Effect of Miller Cycle and Fuel Injection Strategy on Performance of Marine Diesel Engine

**Effect of Miller Cycle and Fuel Injection Strategy on Performance of
Marine
Diesel Engine**

Response to the editor and reviewers

Figure 2: The effect of grid on the pressure: (a) base grid (b) adaptive mesh refinement

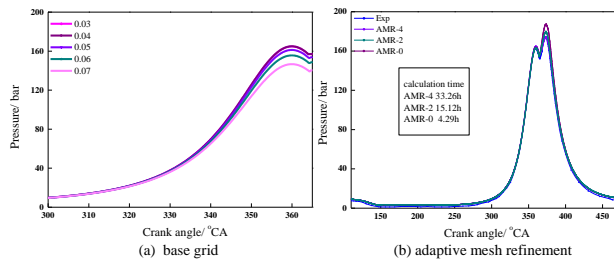
1. It is understood that there is little space in 4 pages to elaborate on a CFD model, but the authors have presented almost nothing, including no references to the modeling approaches, which is not acceptable if they are not going to present their methodology here. There is no information on the mesh resolution, how it was chosen, what the timestep is...The only information provided is that it is a "kappa-epsilon" two equation model. This in my opinion, is not to the standard required. Another passing statement on how soot production is modeled is also provided, but given that the entire paper is based on CFD, I can't possibly recommend acceptance without further information in this section.

Figure 3: Comparison of in-cylinder pressure for the simulation and experiment

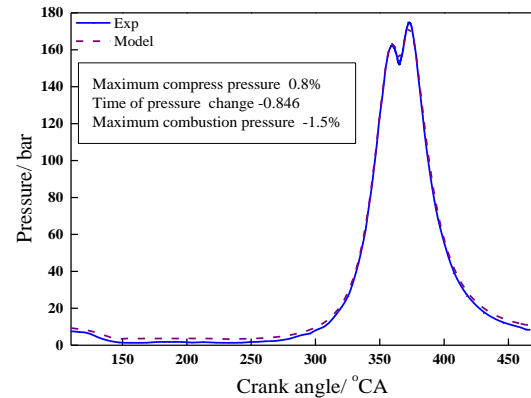
3. Additionally, In section 2.2 the authors state that the errors of "maximum compress pressure and combustion are 0.8% and 1.5%, respectively". What is the "error in combustion", this is extremely vague, but this may just be poor sentence structure? I can't be sure. I believe the authors mean they are comparing maximum in-cylinder pressure during combustion???

Figure 4: Comparison of NO_x and CO_2 for the simulation and experiment

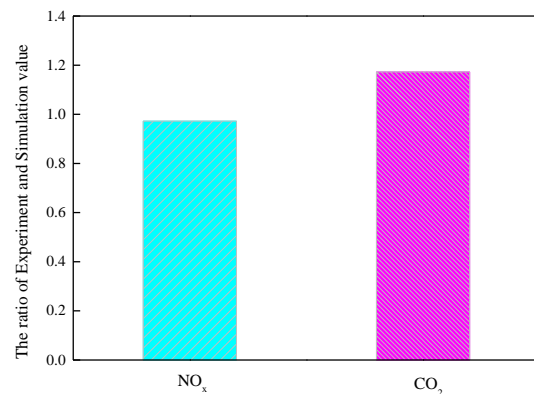
3. The y-axis of Fig. 2 is not sufficient. It needs to be explicitly defined what is being normalized here. a y-axis label of “Experiment/Simulation” as a vertical dimensionless number is not acceptable.
4. A reference is needed to the “Tier III” requirements.
